SUNDRY NOTICES AND REPORTS ON WELLS

HORSESHOE GALLUP #26

Re: Permanent Abandonment

Well: 26 Horseshoe Gallup Unit

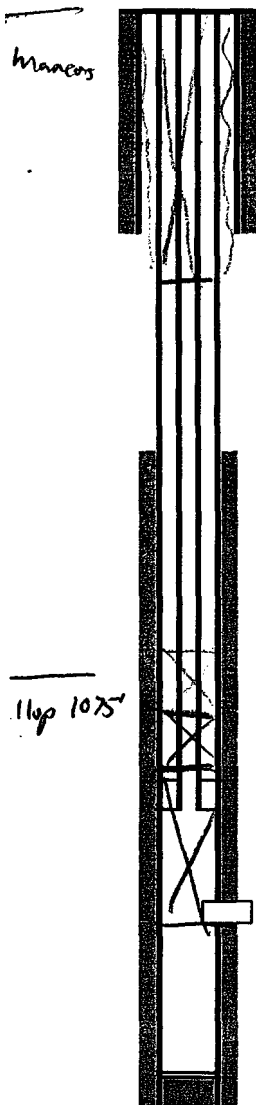
1. Plugging operations authorized are subject to the attached "General Requirements for Permanent Abandonment of Wells on Federal and Indian Lease."
2. Mike Flanikan with the Farmington Office is to be notified at least 24 hours before the plugging operations commence (505) 599-8907
3. The following modifications to your plugging program are to be made:
 - a) Bring the top of the Gallup plug to 1025'.
 - b) Place the surface plug from 150' - surface inside and outside the 4 1/2" casing.

- BLM geologist's pick for the top of the Gallup fm. reflects the top of the transitional Tocito interval in this well. This top varies from operator's pick in this well.

- It is recommended that the Gallup top in this report be adequately covered with cmt.
